Access Compliance Report

Public Rights-of-Way

(Curb Ramps)

Intersection ID: 5741	Main Street: MALLARD_CREEK_RD	Cross Street: NEVIN_RD	Location: SE
ADA ID: 6FA37BB24929	Ramp Type: Perp	Initial Pass/Fail: Fail	Overall Compliance: No
Severity Score: 33.75			
Codes/Mitigation Info/Possible Solution		Field Measurements/Component Compliance

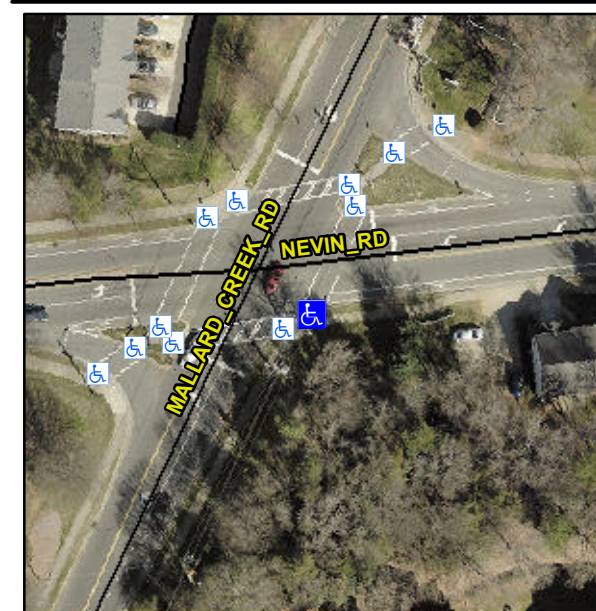
Not Found, R304.5.1, R304.2.2

Compliance	Description	Data	Compliance	Description	Data
N/A	Ramp Length (in)	49.0	No	Ramp Slope (%)	13.5
No	Ramp Width (in)	47.0	Yes	Ramp XSlope (%)	1.0
N/A	Flare Type LT	N/A	N/A	Flare Type RT	N/A
N/A	Flare Slope LT (%)	N/A	N/A	Flare Slope RT (%)	N/A
N/A	Flare Traversable LT?	N/A	N/A	Flare Traversable RT?	N/A
N/A	Landing Length (in)	N/A	N/A	DWS Provided?	N/A
N/A	Landing Width (in)	N/A	N/A	DWS Contrast?	N/A
N/A	Landing Slope (%)	N/A	N/A	DWS Length (in)	N/A
N/A	Landing X Slope (%)	N/A	N/A	DWS Full Width?	N/A
N/A	Landing Curb? (Y/N)	N/A	N/A	DWS Offset (in)	N/A
N/A	Shared Landing?	N/A			
N/A	Gutter Ponding?	N/A	N/A	Gutter Slope (%)	N/A
N/A	Gutter Lip Ht (in)	N/A	N/A	Gutter X Slope (%)	N/A
N/A	Painted X Walk1?	Yes	N/A	Painted X Walk2?	N/A
	X Walk 1 Direction	To NE		X Walk 2 Direction	N/A
N/A	X Walk 1 Width (in)	158.0	N/A	X Walk 2 Width (in)	N/A
	X Walk 1 Slope (%)	1.7		X Walk 2 Slope (%)	N/A
	X Walk 1 X Slope (%)	0.6		X Walk 2 X Slope (%)	N/A

Remove & Replace Entire Ramp.
